**BELLEFONTE COMBINED LICENSE APPLICATION – RESPONSE TO REQUEST FOR
ADDITIONAL INFORMATION – EVACUATION TIME ESTIMATE**

Supplement 1 to the Bellefonte ETE Report

Revision 1

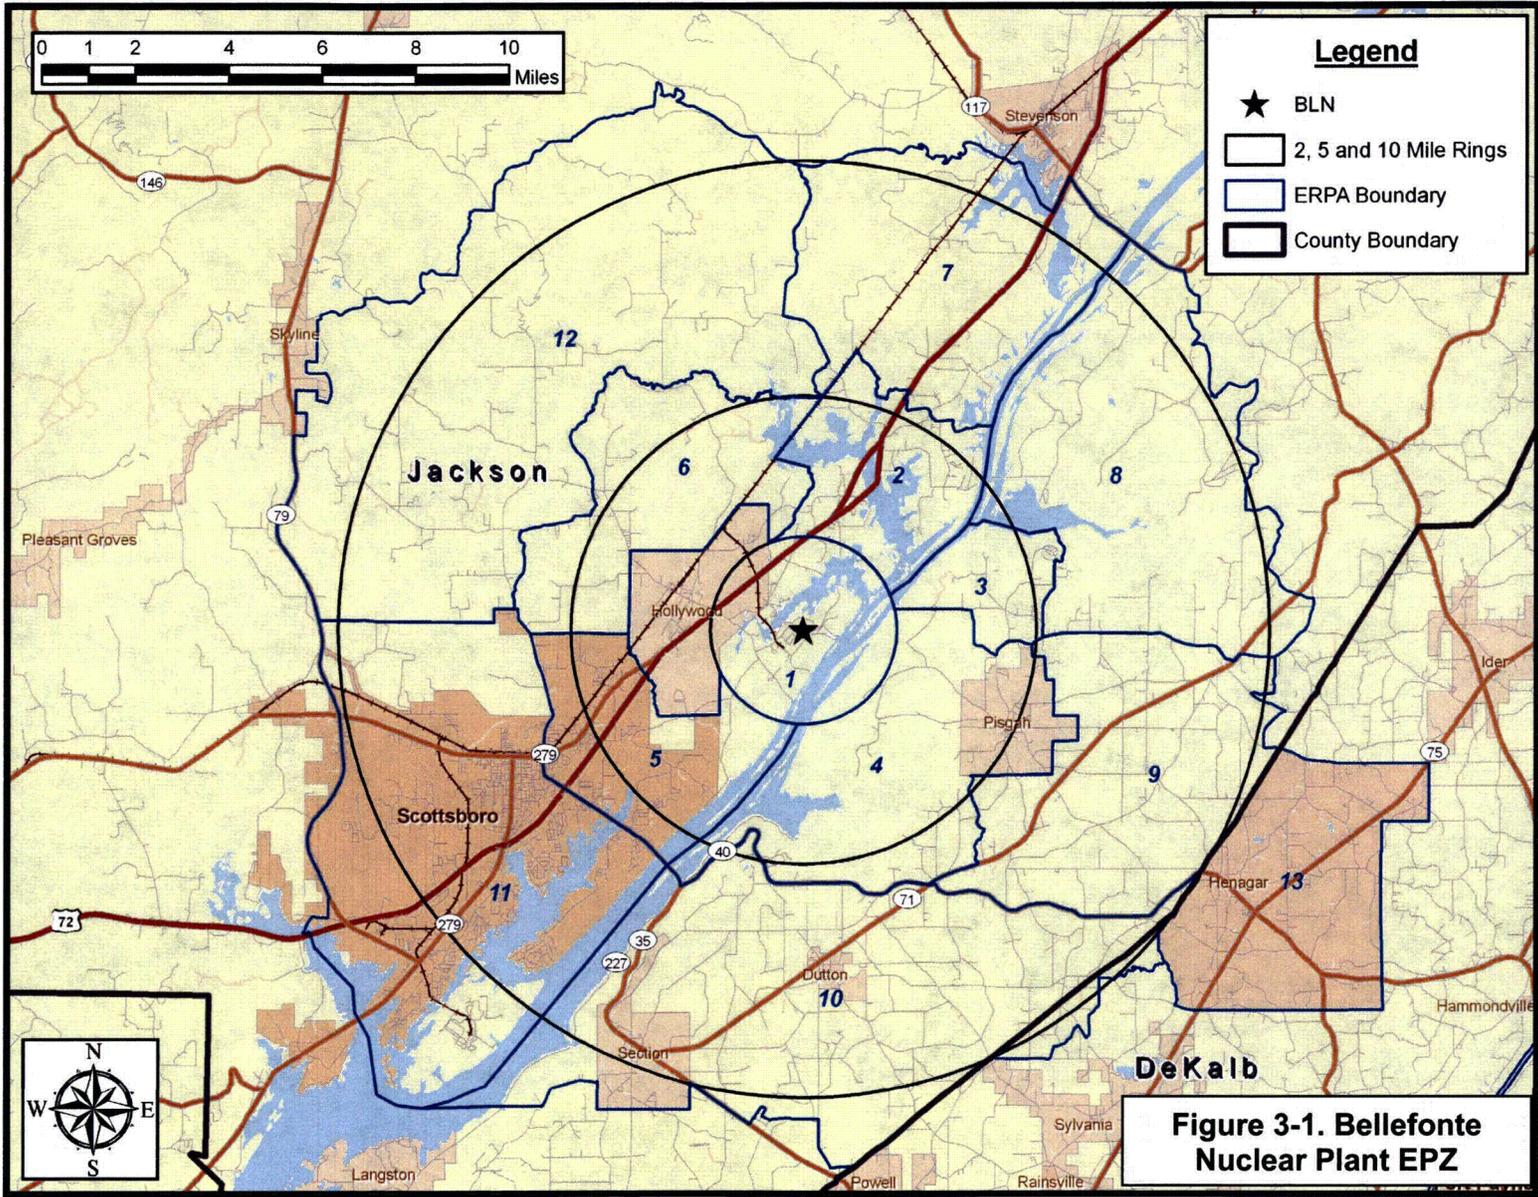
- Updated figure by adding county boundaries to the map, labeling Jackson and DeKalb Counties, and adding county boundary to the legend. See updated figure provided in this Errata Sheet.

Figure 3-6. Employee Population by Sector

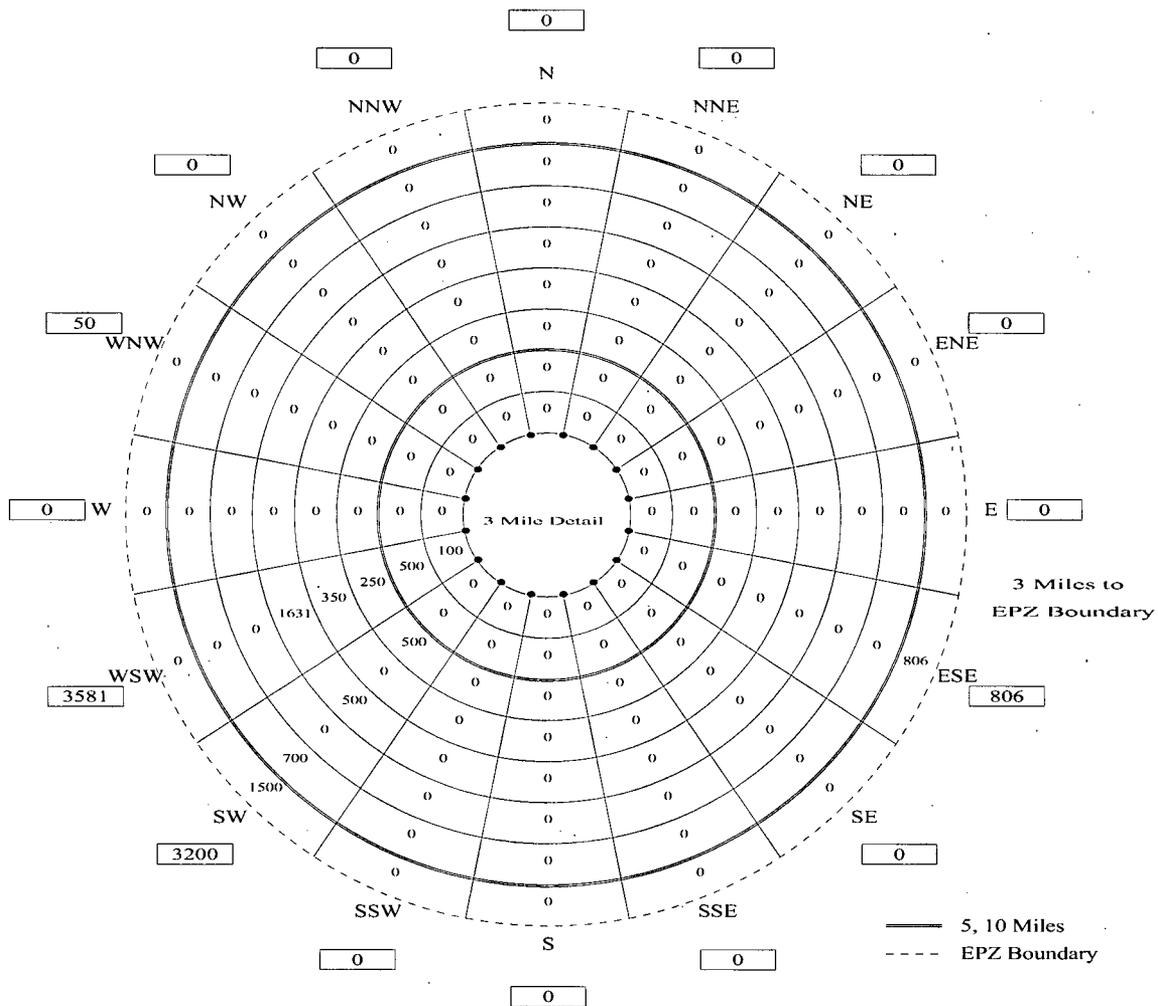
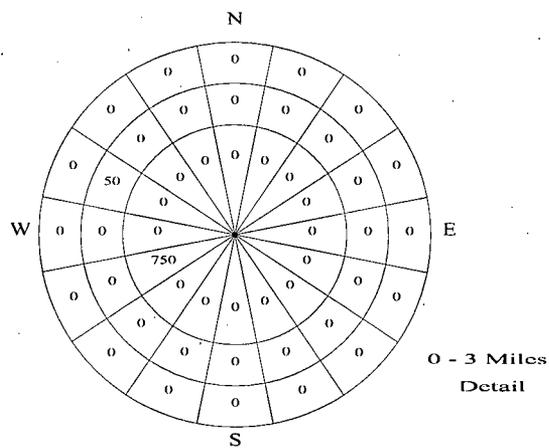
- Corrected by moving the figure "806" for the ESE, 9-10 mile cell to the ESE, 10-EPZ boundary cell. Corrected the table summarizing employees in the lower left corner of the Figure accordingly. See corrected figure provided in this Errata Sheet.

Figure 3-7. Employee Vehicles by Sector

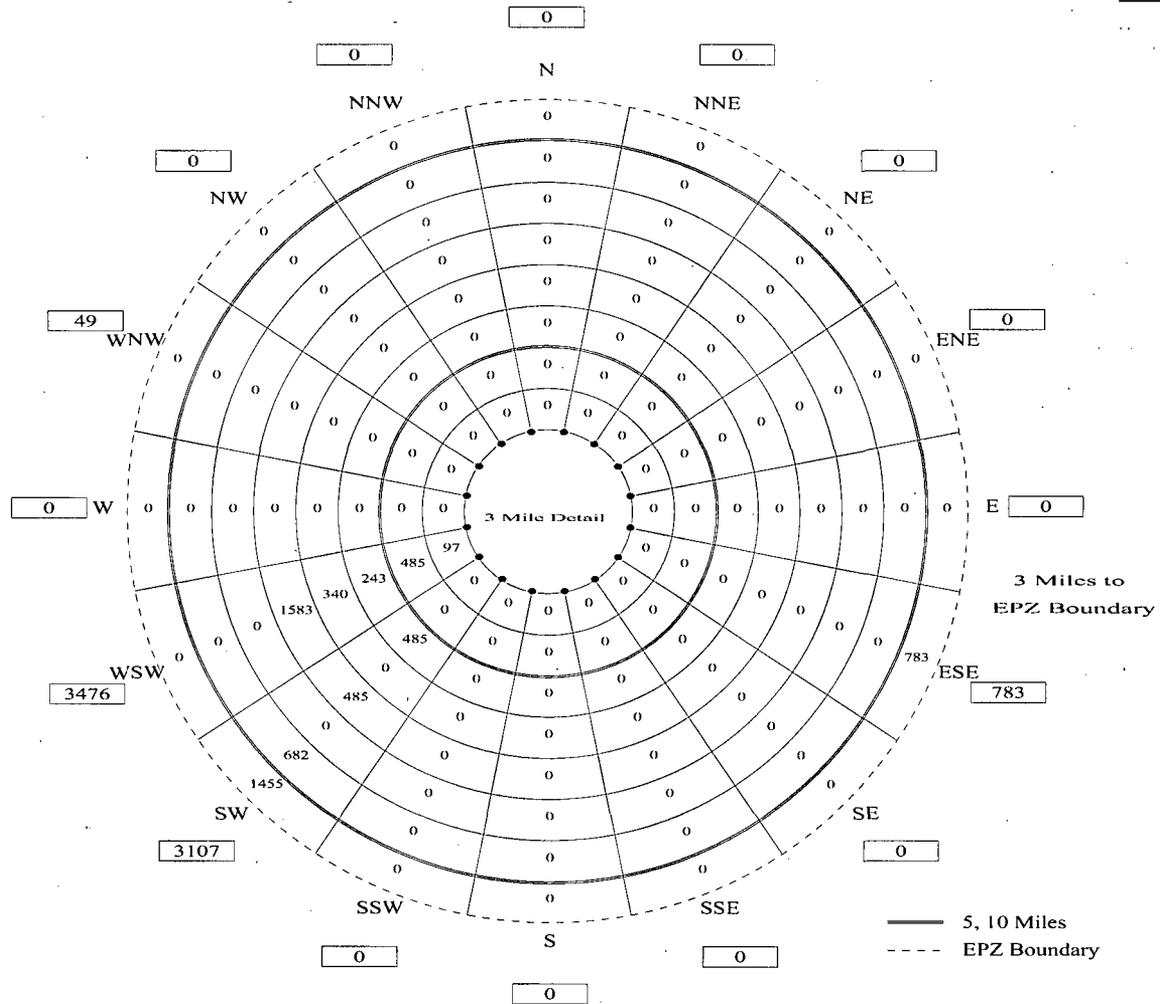
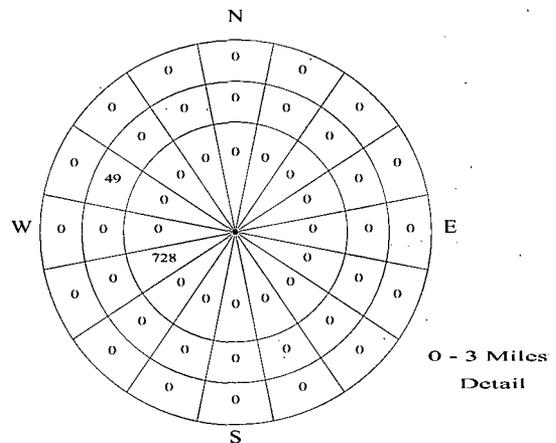
- Corrected by moving the figure "783" for the ESE, 9-10 mile cell to the ESE, 10-EPZ boundary cell. Corrected the table summarizing employee vehicles in the lower left corner of the Figure accordingly. See corrected figure provided in this Errata Sheet.

Figure 5-1. Events and Activities Preceding the Evacuation Trip

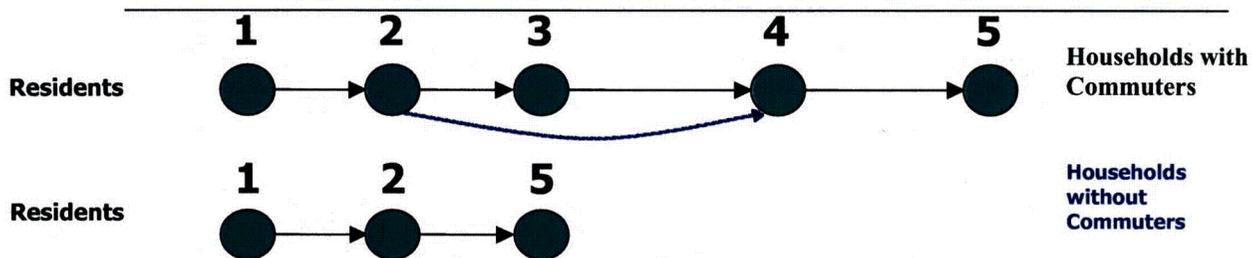
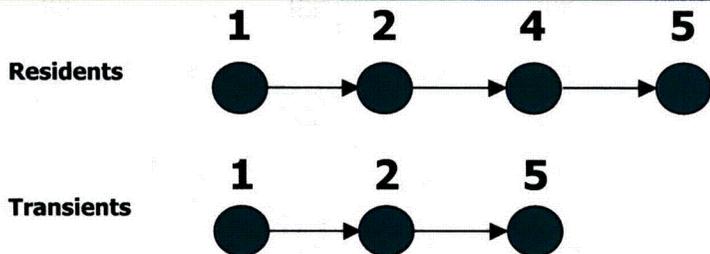
- Corrected Figure 5-1 to agree with the text on Page 5-5. See corrected figure provided in this Errata Sheet.

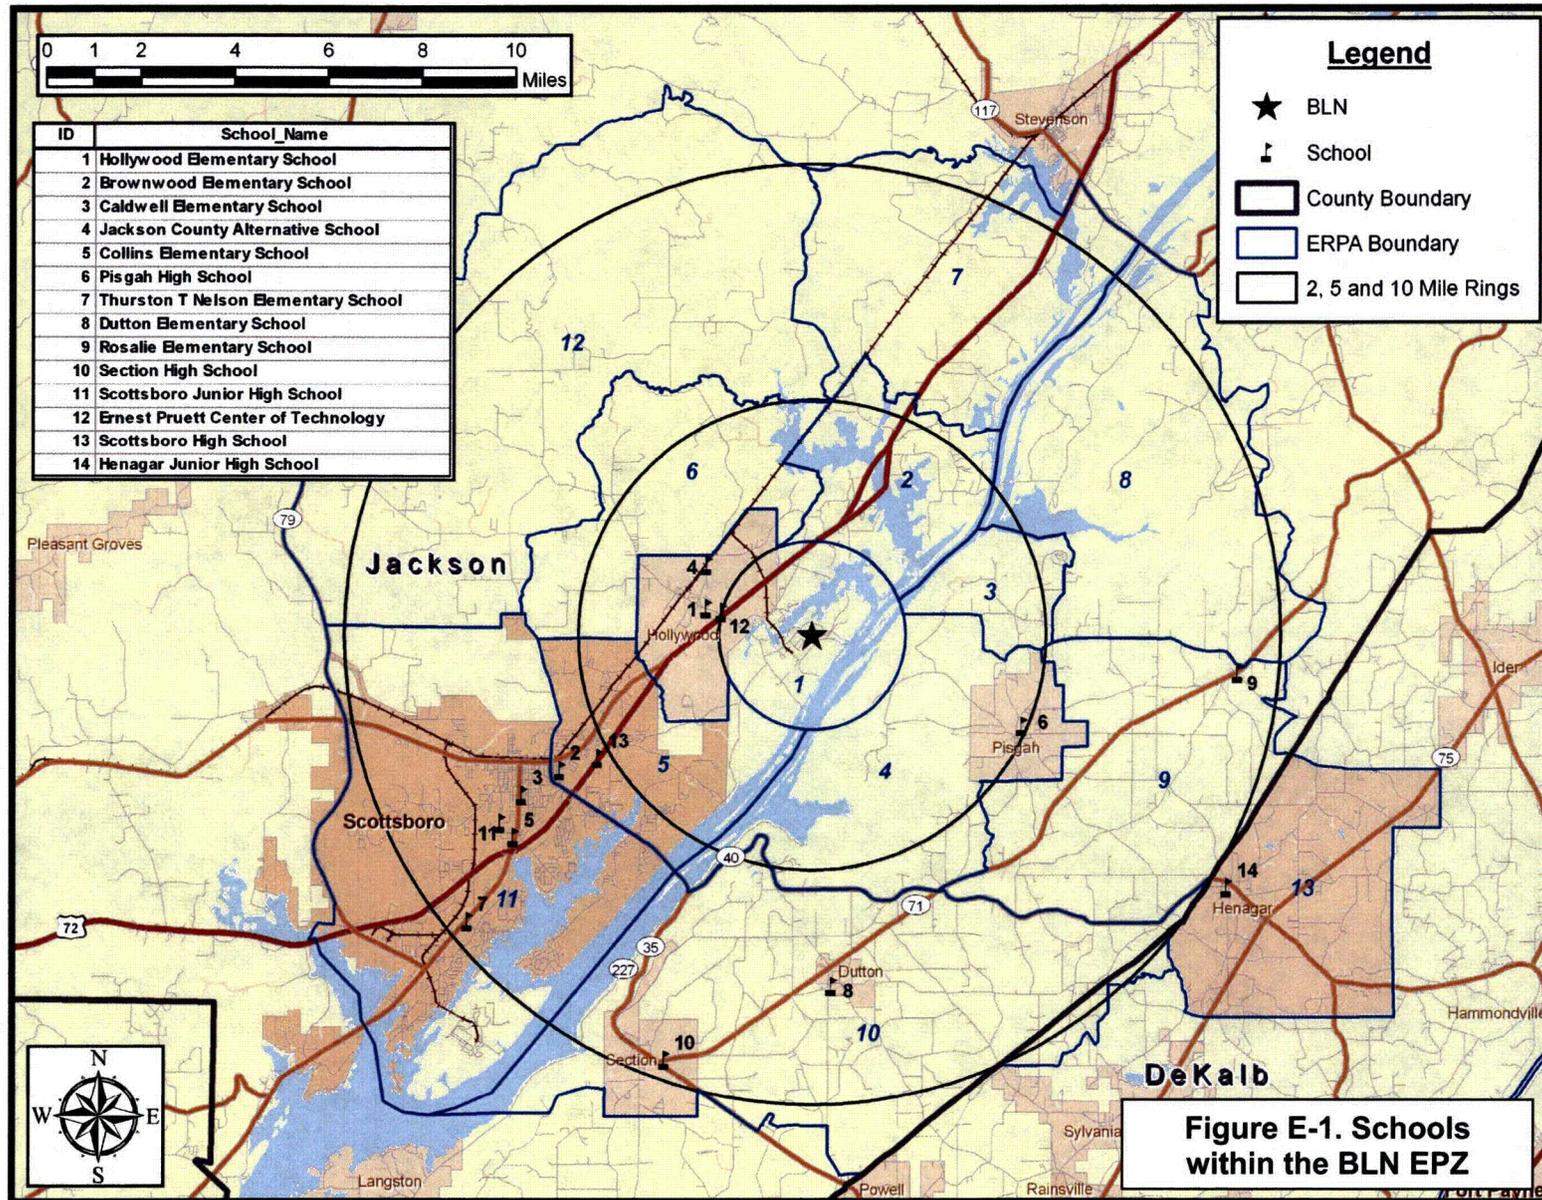
- Supplemented by adding Figure E-1, a GIS map of all schools within the BLN EPZ. See supplemental figure provided in this Errata Sheet.

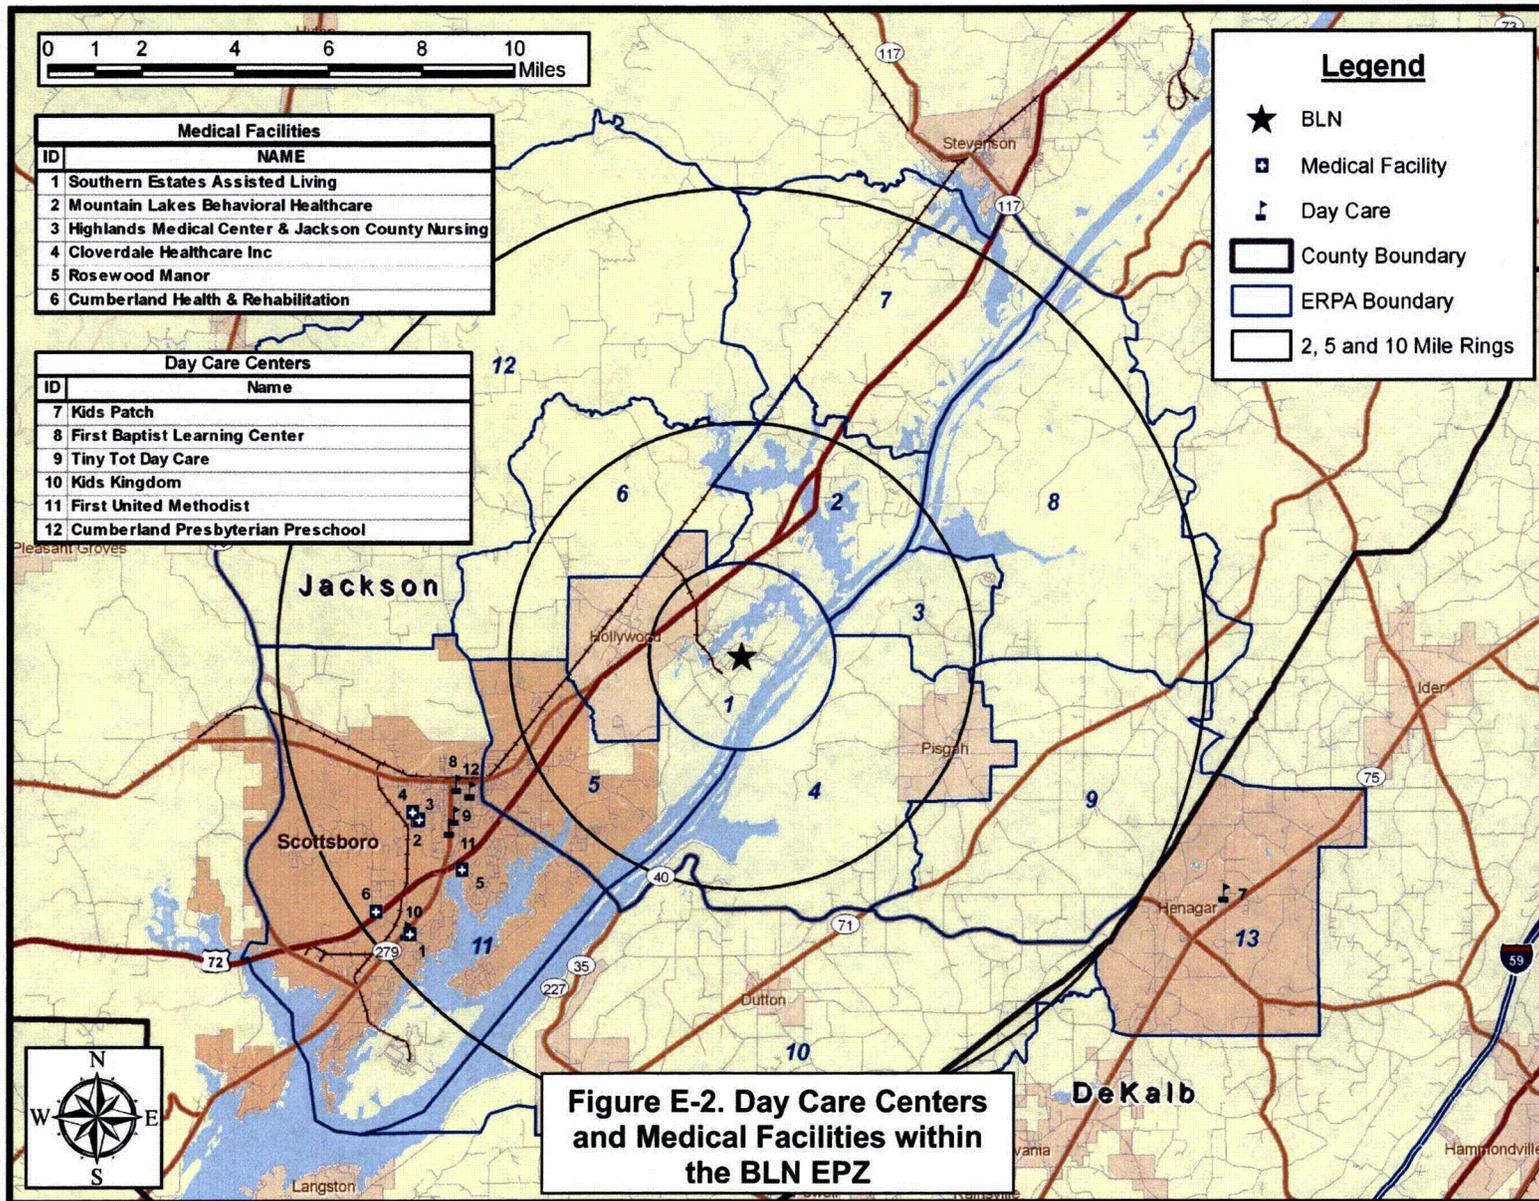
- Supplemented by adding Figure E-2, a GIS map of all day care centers and medical facilities within the BLN EPZ. See supplemental figure provided in this Errata Sheet.

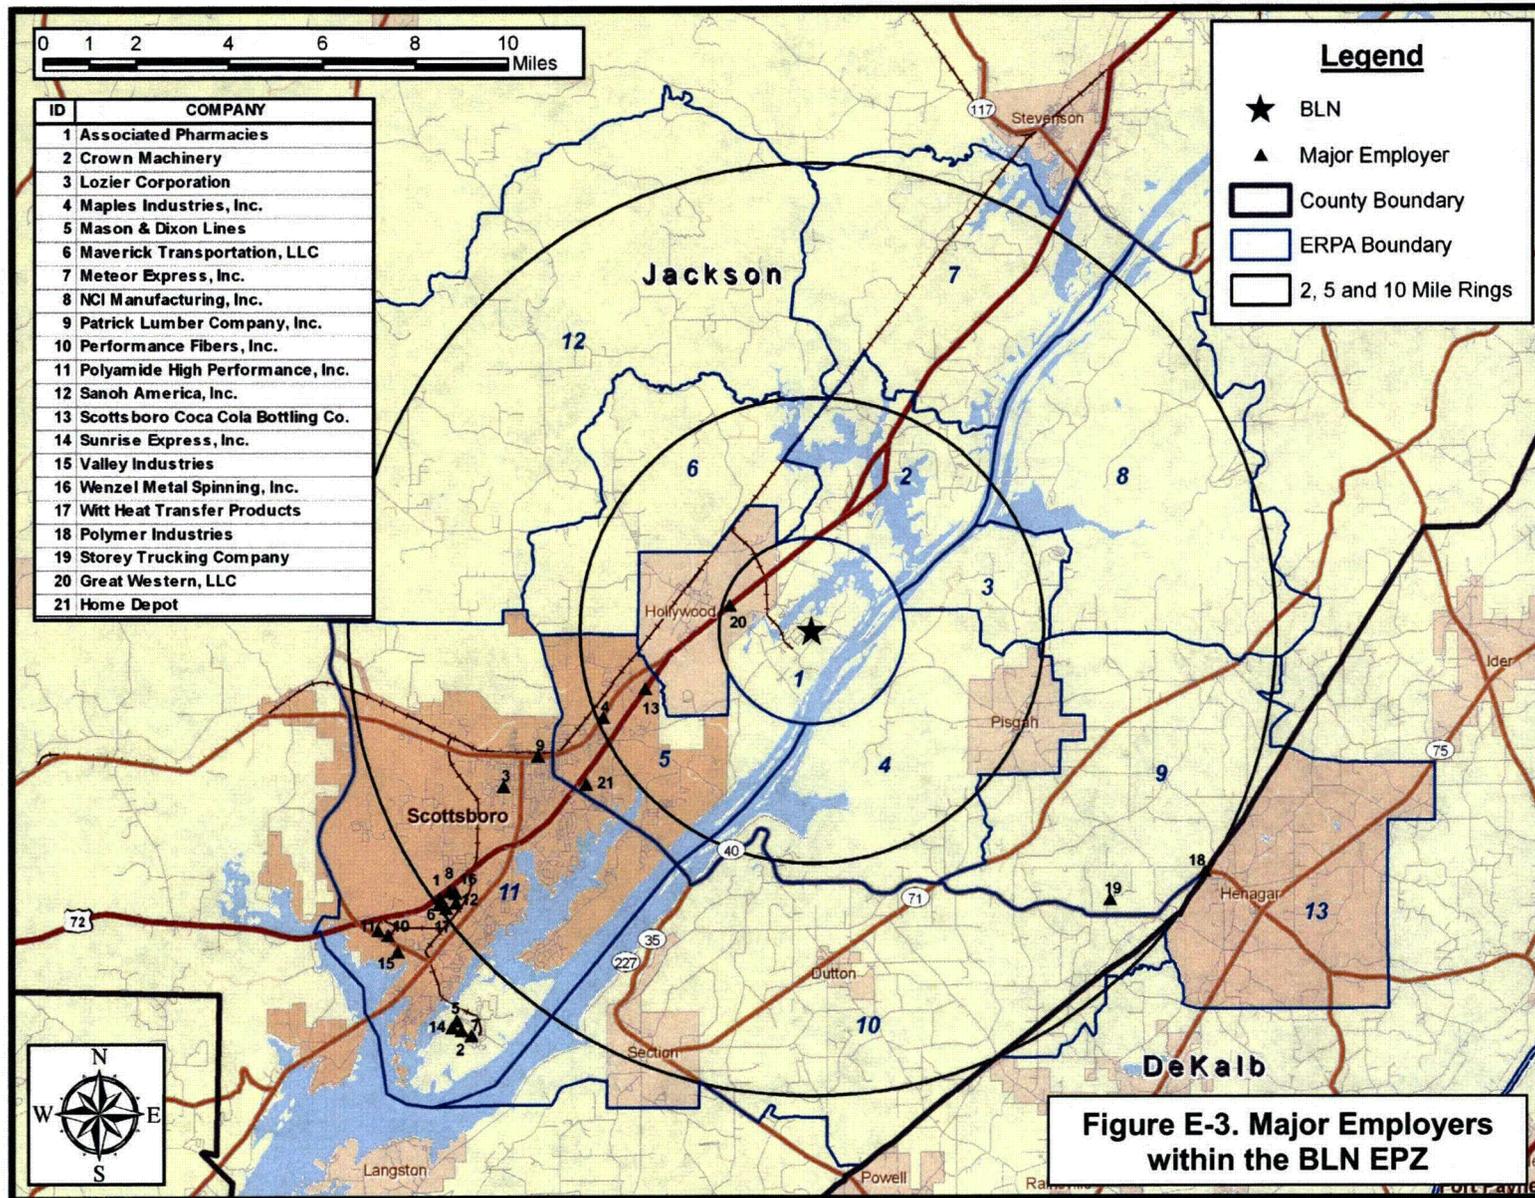
- Supplemented by adding Figure E-3, a GIS map of all major employers within the BLN EPZ. See supplemental figure provided in this Errata Sheet.
